Invitation for Bid No. 2023-066

Piedmont Innovation Park Sanitary Sewer

ADDENDUM No. 1
ISSUE DATE: August 22, 2023

Union County, NC
Piedmont Innovation Park Sanitary Sewer
WKD Project Number: 20190559.00.CL

BID SET - NOT RELEASED FOR CONSTRUCTION
 PROJECT NAME: **PIEDMONT INNOVATION PARK**
SANITARY SEWER
 CITY OF MONROE PROJECT # 22-02
 DRAWING TITLE: **EXISTING MH 1 TO PROPOSED SSMH-7**

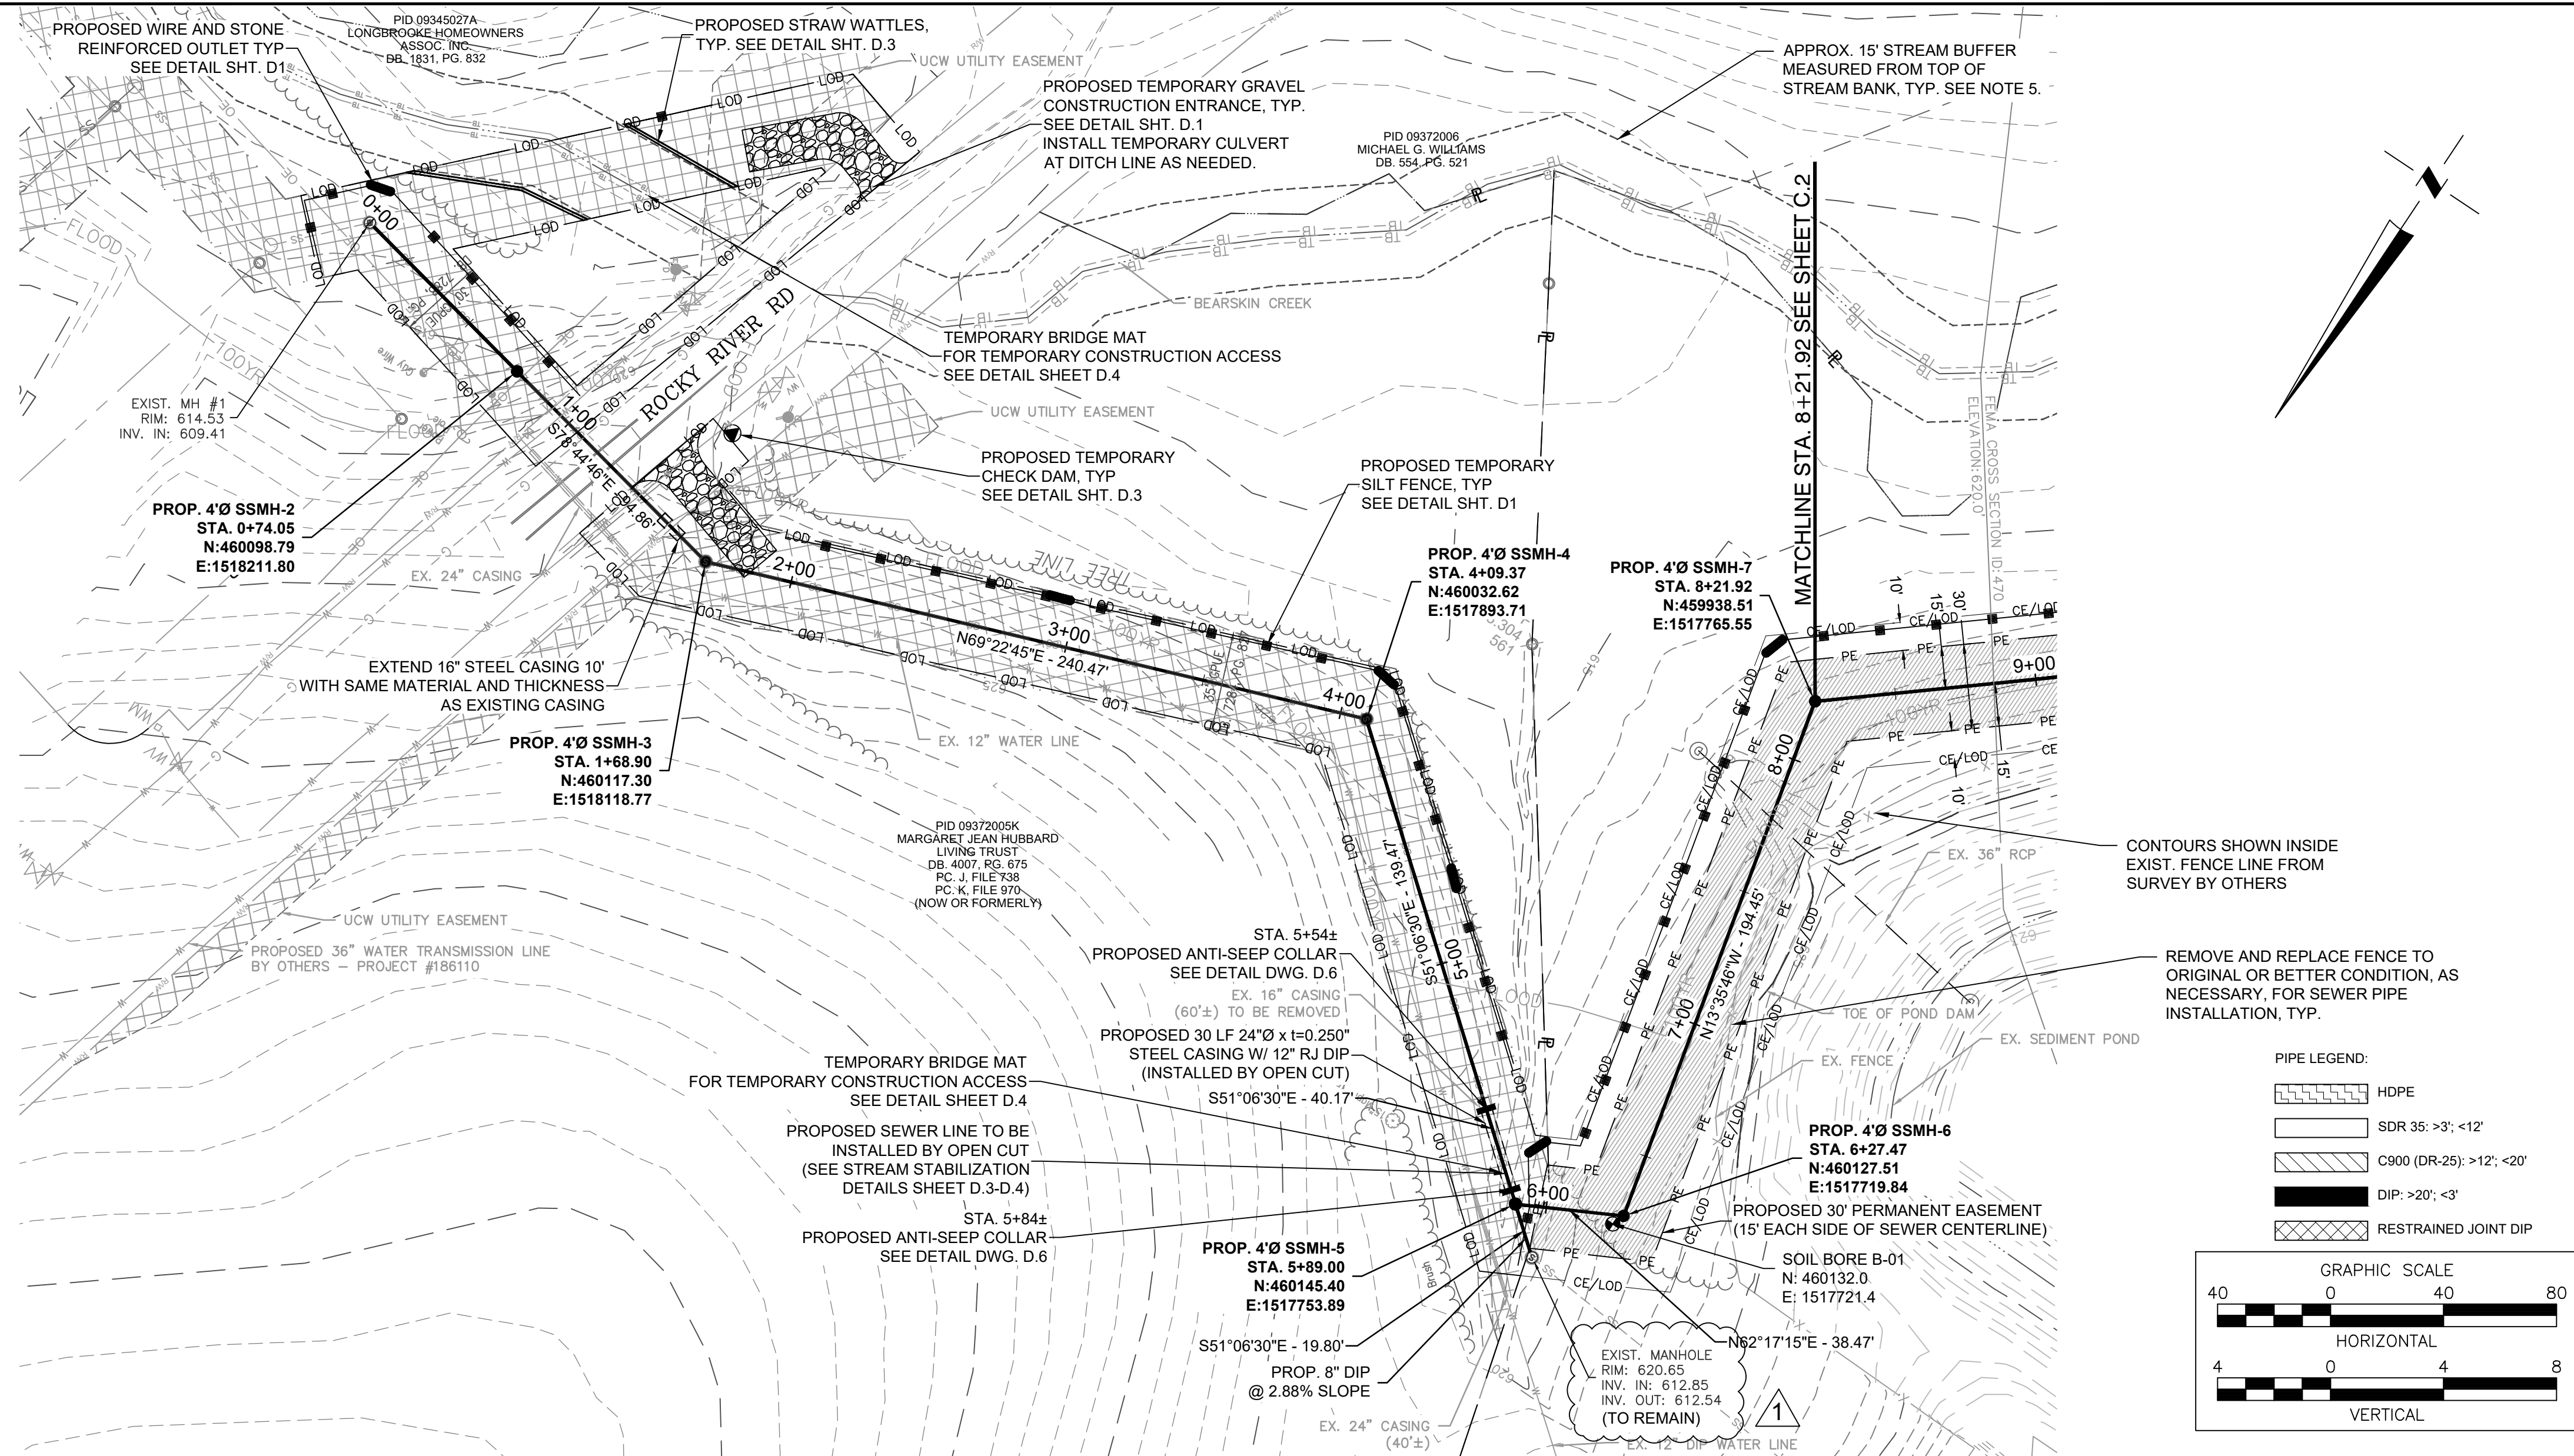
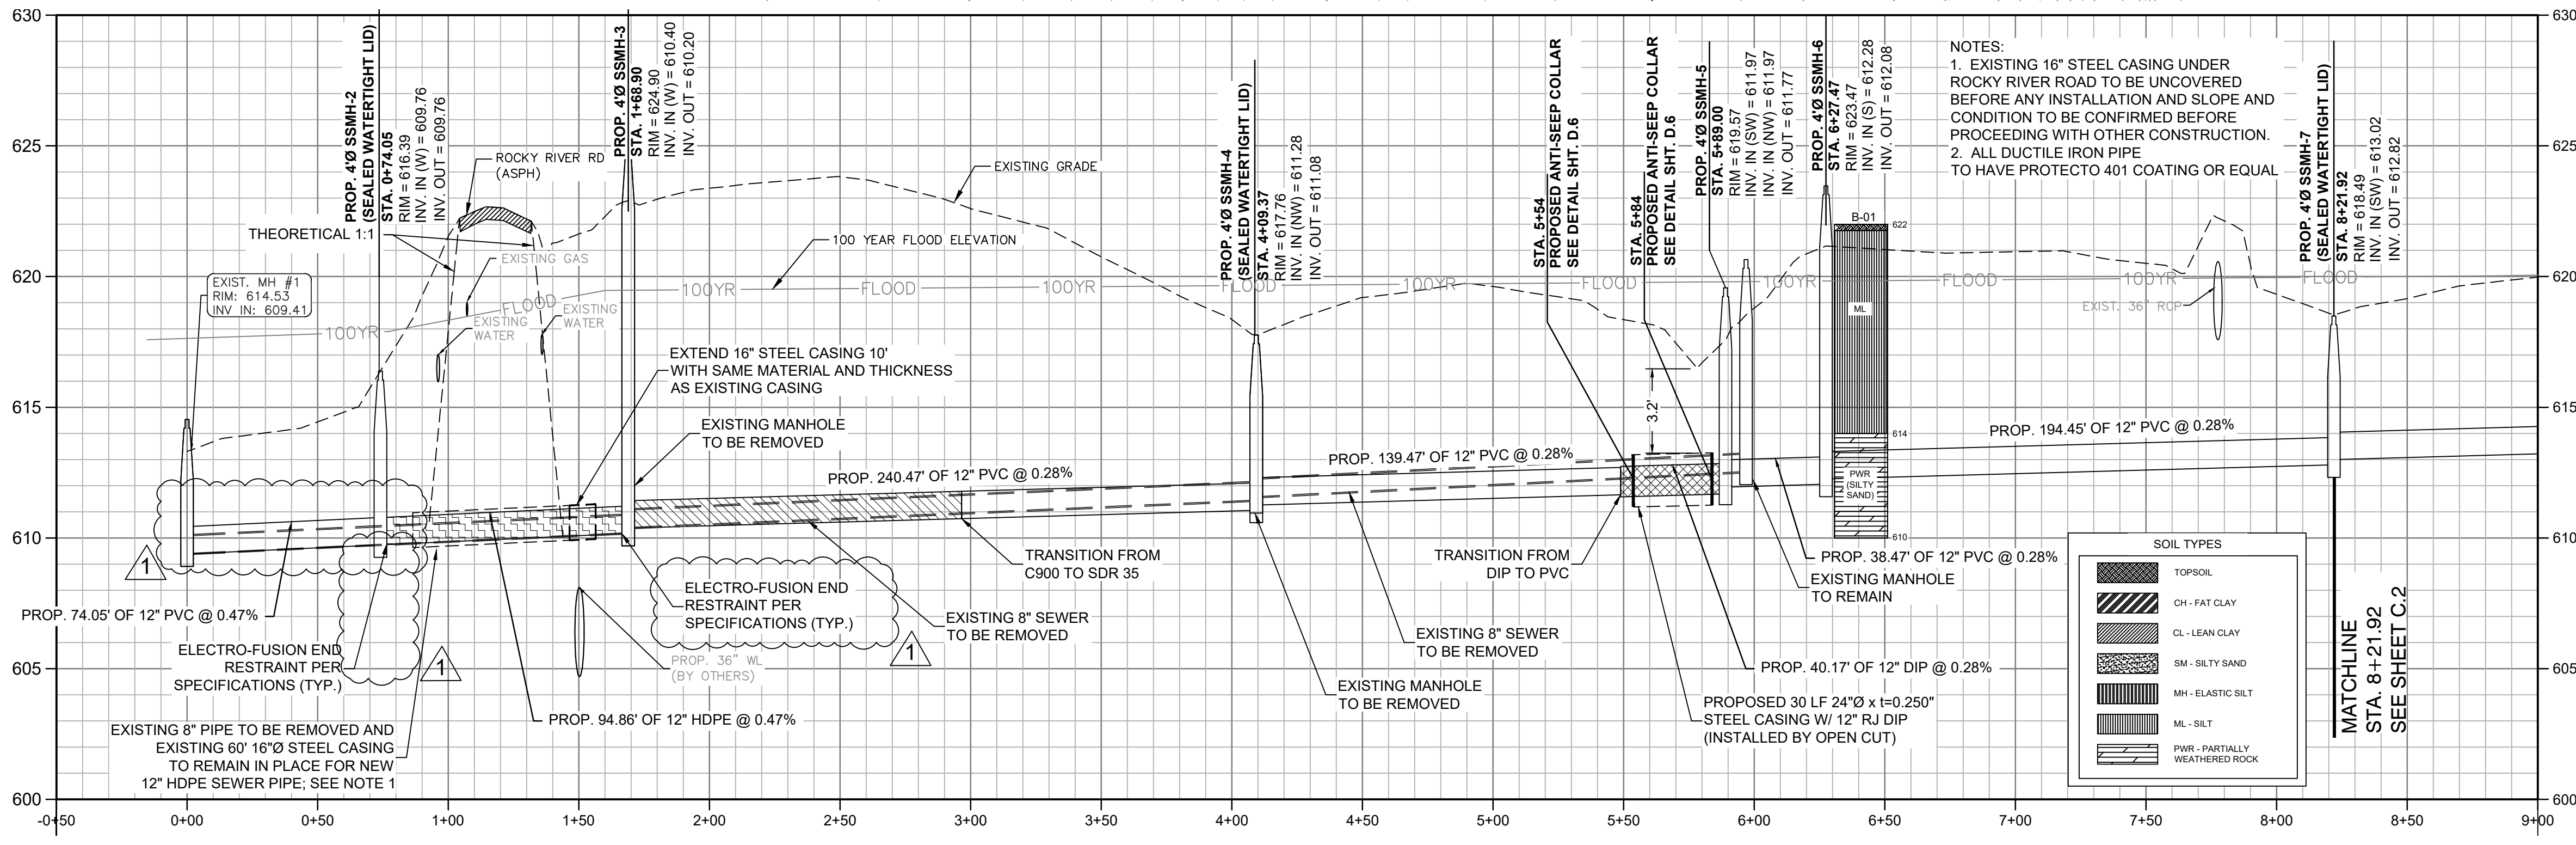
Item 4: Sheet C.1 – Existing MH 1 to Proposed SSMH-7. Changes Includes:

- a. Updating hatching from existing MH #1 to SSMH#2 to SDR 35.
- b. Updating call out "ELECTRO-FUSION END RESTRAINT PER SPECIFICATIONS (TYP.)" from existing MH #1 to SSMH #2.

- c. Add call out "ELECTRO-FUSION END RESTRAINT PER SPECIFICATIONS (TYP.)" to SSMH #3.
- d. Updating Rim Elevation from 613.62' to 620.65' for Existing Manhole upstream of proposed SSMH#5 on plan view.
